Subject: RE: VA-22-00002 Heidt - Notice of Application Date: Thursday, April 21, 2022 8:53:32 AM

COMMENTS: Project VA-22-0002: Heidt Setback Variance Subject: Date: Wednesday, May 4, 2022 8:40:51 PM

SUBJECT: VA-22-00002 Heidt

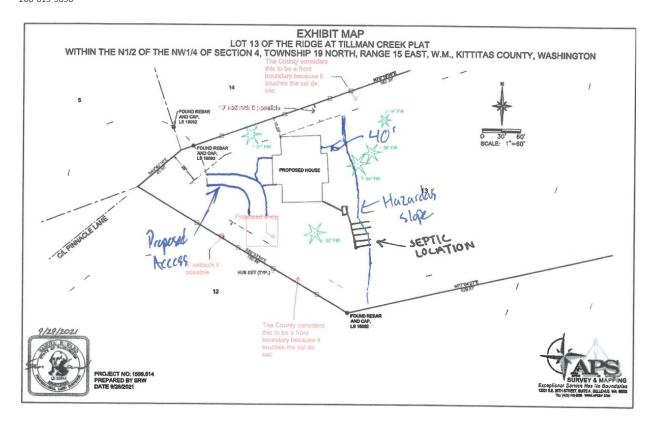
In principle, we have no exception to the request if both of the following provisions can be affirmed.

- 1. The grant of the 15' variance (10' setback) would not encumber us in any way from positioning a structure directly across the property line in accordance with appropriate setbacks.
- 2. The grant of the 15' variance (10' setback) would not create a Firewise concern which could result in the removal of a 32" Fir on our property that sits 6' off the property line. NOTE: I contacted the Fire Marshall, Ryan McAllister and his email of May 3, 2022 noted, "This will not affect your property or the tree that is on your lot." We're confident he is in the know, but the final judgment comes from your office, so we are looking for your confirmation please.
